Review of  
Potential Impacts of the Proposed Rosemont Mine,  
southeast of Tucson, Arizona  
on  
Las Cienegas National Conservation Area (LCNCA)  
Hydrologic System

Friday, May 6, 2016

Prepared by  
Robert H. Prucha, Phd, PE  
Integrated Hydro Systems, LLC  
Golden, Colorado

Figure 2. Many alternative conceptual models could have been considered, just based on uncertainties in available structural geologic information as indicated here at red circles.

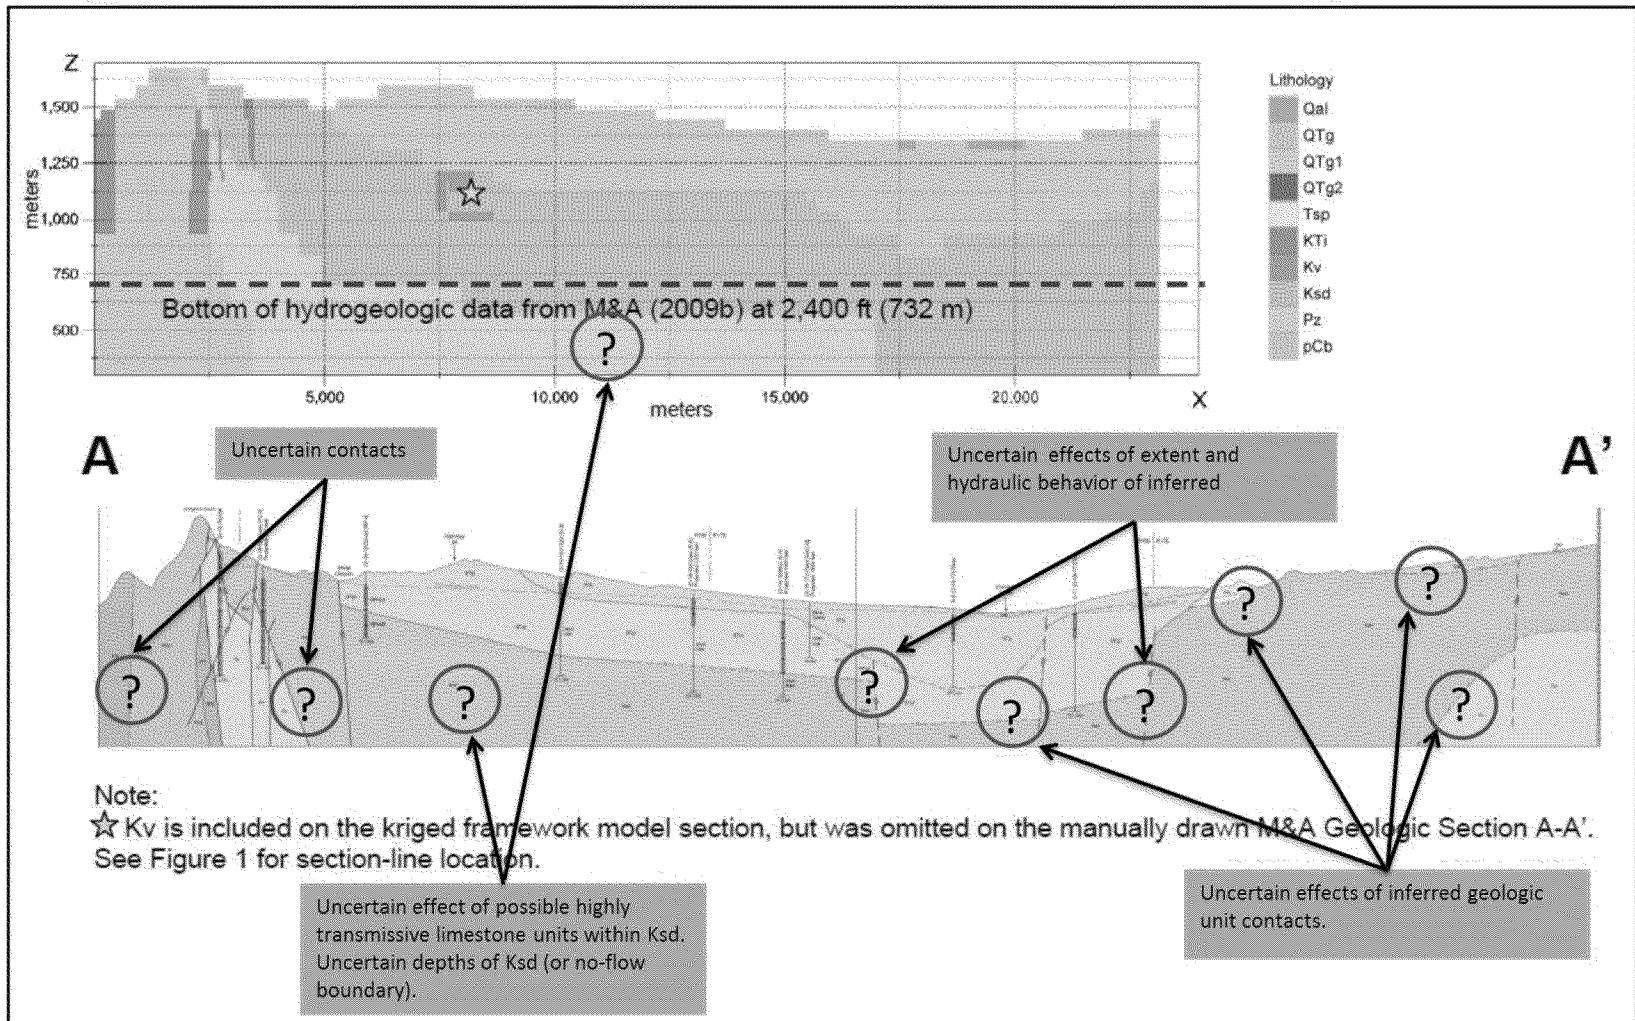
- 3) **Conceptualization.** Though Rosemont consultants developed two different models, a realistic range of alternative conceptual models were not considered in the modeling that account for substantial uncertainty in virtually all model input (Figure 2 below shows examples of some alternatives that could have been considered and which would have had a notable impact on predictions). This only increases the non-uniqueness of the solution, which in turn produces high uncertainty in predictions that weren't considered in the parametric sensitivity simulations (which shouldn't be confused with uncertainty analysis). Neuman and Weiranga, 2003 describe in detail how to incorporate alternative conceptual models into formal uncertainty analyses. Typically, conceptual model uncertainty dominates overall predictive uncertainty and as such should have been more fully assessed.

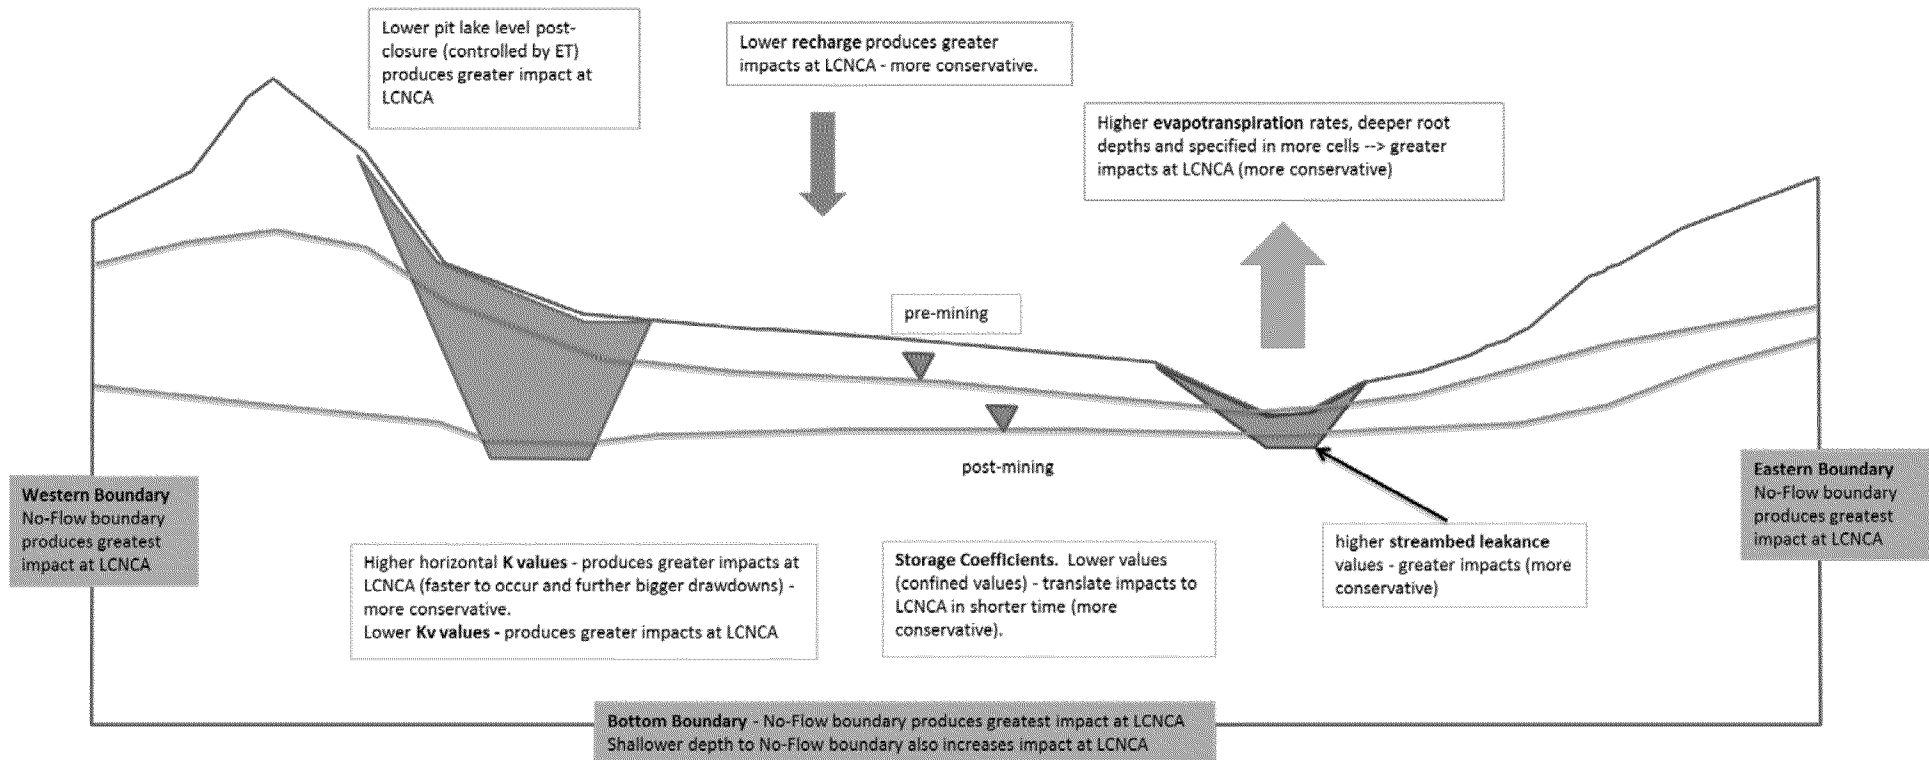
- 7) **Sensitivity and Uncertainty Analyses.** The predictive sensitivity analysis conducted by the Rosemont modelers did not consider all of the factors that could have 'conservatively' increased the range of potential impacts within the LCNCA. Figure 3 summarizes key factors I believe should have been considered individually and collectively to assess a more realistic conservatively high range of impacts in the LCNCA. It remains unclear why the modelers wouldn't have also evaluated different combinations of adjustments to 'sensitive' parameter values, or different configurations of spatially distributed parameters (versus just adjusting all values up or down some arbitrary amount). Adjustments to combinations of sensitive parameters could easily produce much greater impacts in the LCNCA than adjustments to just individual parameter values.

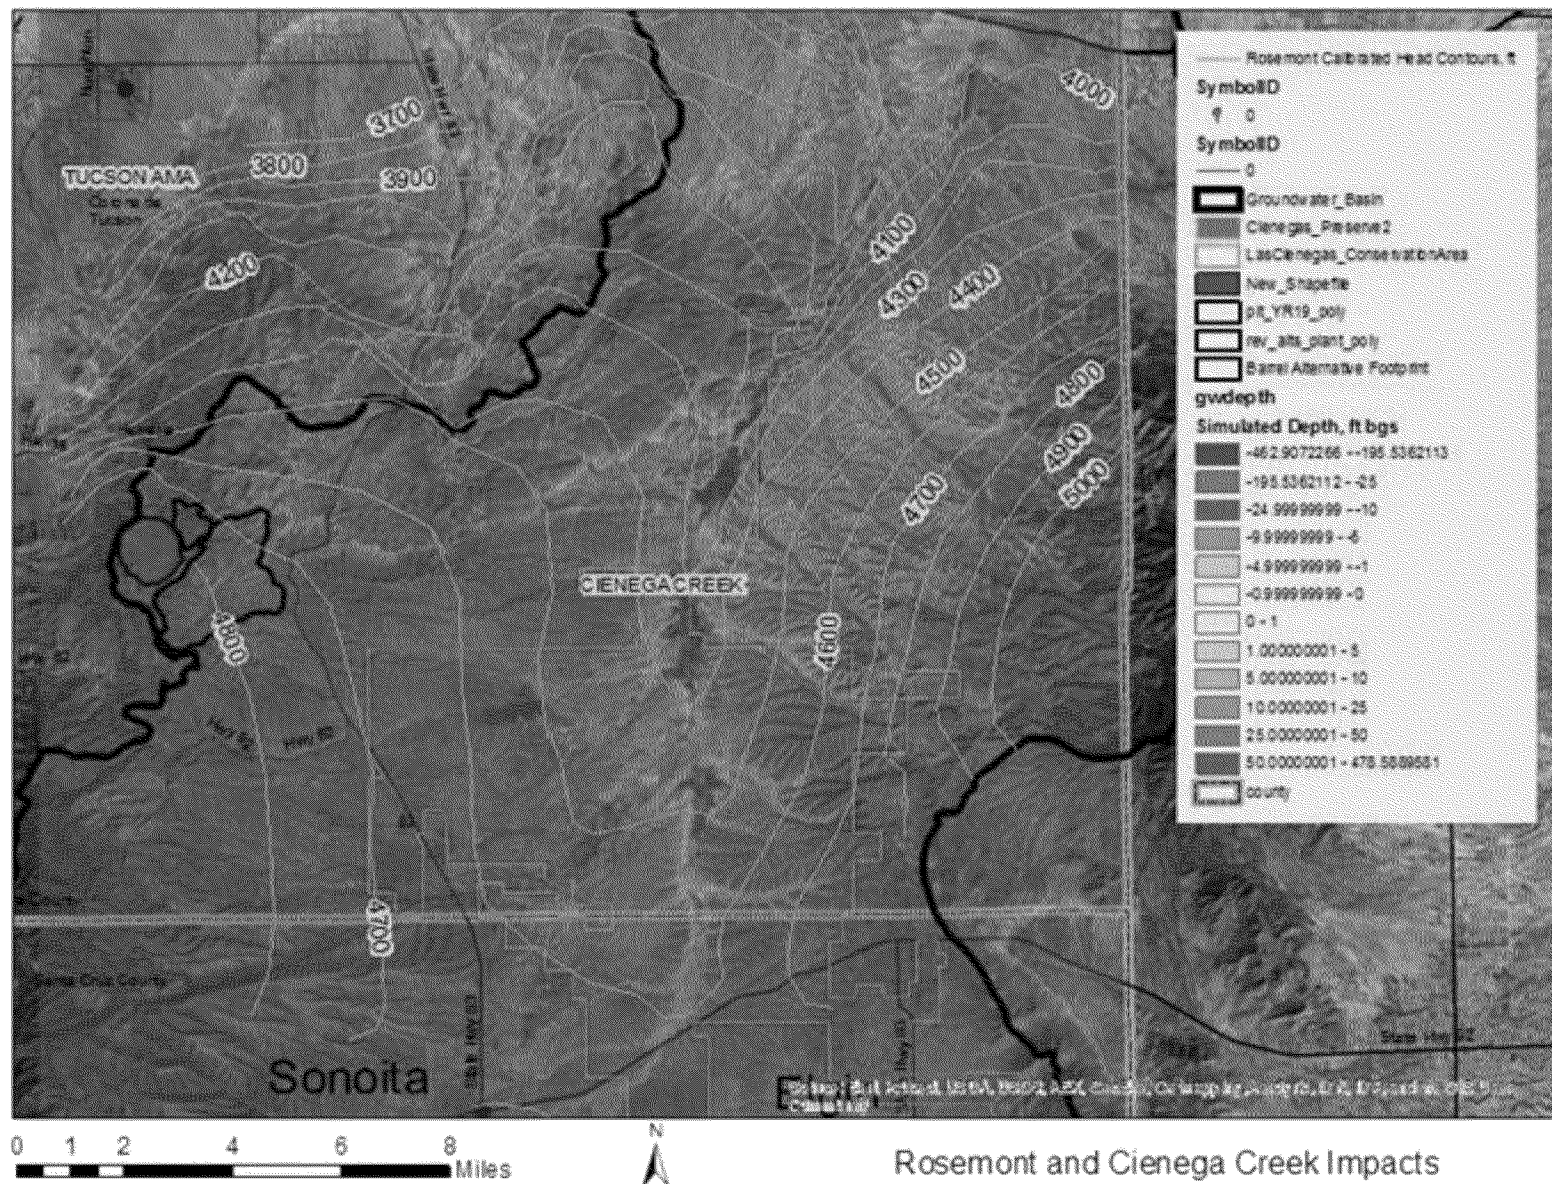
- c. I created a spatial plot of simulated groundwater depths (see Figure 4), which I calculated in ArcGIS from a plot showing simulated groundwater levels from the calibrated model and available 10m topographic DEM data. Results appear to show significant areas in the vicinity of LCNCA with heads >10 to 100+ feet above ground surface. This by itself suggests calibration results within LCNCA area is not properly constrained, poor and highly unreliable. Groundwater levels should not be simulated above ground surface, except by a few feet beneath topographic drainages, unless data clearly show that high artesian pressures exist – which by itself would also require the modelers to also revisit the conceptual flow model (which doesn't show this).
